# Replacing Oil Pressure Switch CNT00553

Using CNT05044

Models: CRHR, CRHM, CNT00553 and CNT06044

PART-SVN105A-EN

Figure 2. Internal view of new pressure switch and mounting bracket

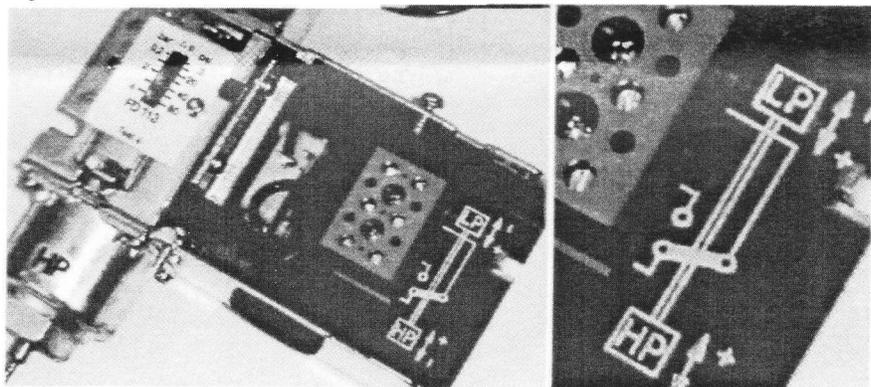
- 4 The shape and mounting of the new switch is very different than the original switch. Secure the new switch (CNT05044) to the unit. The location of the new switch should be determined by application.

- a **Be close enough to the compressor so that the capillary tubes** easily reach from the switch to the connection points on the compressor.
  - b Allow for wiring to the CNT01312 motor controller located in the Unit Control Panel.
  - c Be free from excessive vibration and thermal exposure.
  - d Use the two mounting screws and washers provided to secure the mounting bracket to the back of the switch. Screws are less than 5 mm in length to prevent damage to the switch internal components.
- 5 Connect both capillary tubes from the new pressure switch to the compressor. The tube labeled HP should be connected to the pump discharge and other connection to the compressor suction. See Figure 2 for switch details. The original switch lube capillary went to pump discharge just like the new HP tube.

Connect the P1 electrical terminal on the motor protector to the top or common terminal on the CNT05044. Connect the P2 electrical connection on the motor protector to the normally open terminal located in the center of the terminal block as shown in Figure 3. Secure wires appropriately. Make sure old wires are removed or terminated.
